INDESIT company

Model type:
BAAN13

Commercial code:
F034171

N1030093fig1

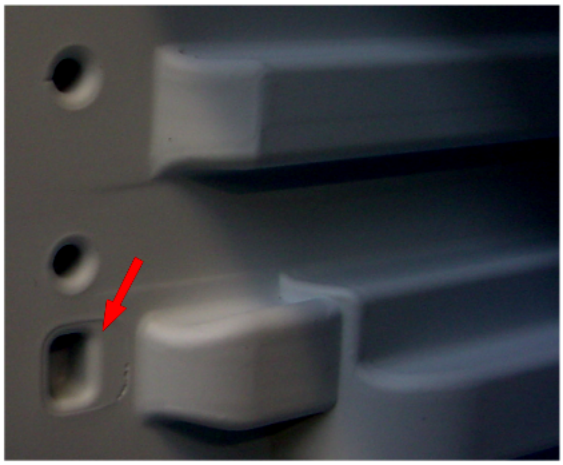
# n1030093: New fixing of evaporator on static fridge-freezers (05 range) 60 cm,Melano

From August 05 (serial no. 50802.0001) the freezer evaporator is secured to the cabinet by a plastic profile.
The cabinet walls have been modified to create locations to house the profile, which is installed on the front of each evaporator plate (see photo N1030093fig1- fig2 - fig3)
The profile cannot be fitted on premodification appliances, so technical personnel must continue to fit the rh and lh supports on these models (see photo N1030093fig4)

New parts
C00141135 = WHITE PROFILE L=443.5 MM

Parts replaced
C00075596 = EVAPORATOR RH SUPPORT
C00075597 = EVAPORATOR LH SUPPORT

N1030093fig1

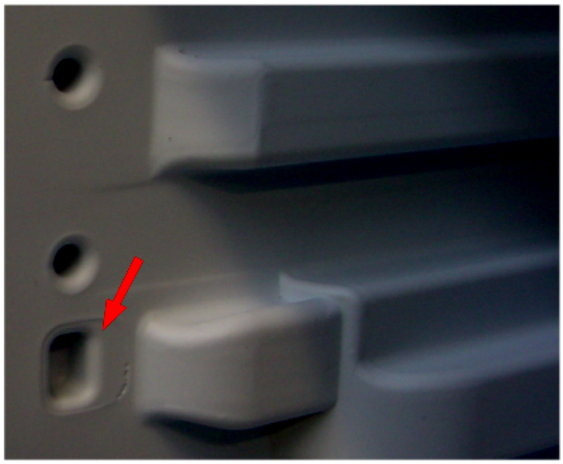
## n1030094: New fixing of evaporator on static fridge-freezers (05 range) 60 cm, Lodowek

From August 05 (serial no. 50820.0001) the freezer evaporator is secured to the cabinet by a plastic profile.
The cabinet walls have been modified to create locations to house the profile, which is installed on the front of each evaporator

plate (see photo N1030093fig1- fig2 - fig3)
The profile cannot be fitted on premodification appliances, so technical personnel must continue to fit the rh and lh supports on these models (see photo N1030093fig4)

New parts
C00141135 = WHITE PROFILE L=443.5 MM

Parts replaced
C00075596 = EVAPORATOR RH SUPPORT
C00075597 = EVAPORATOR LH SUPPORT
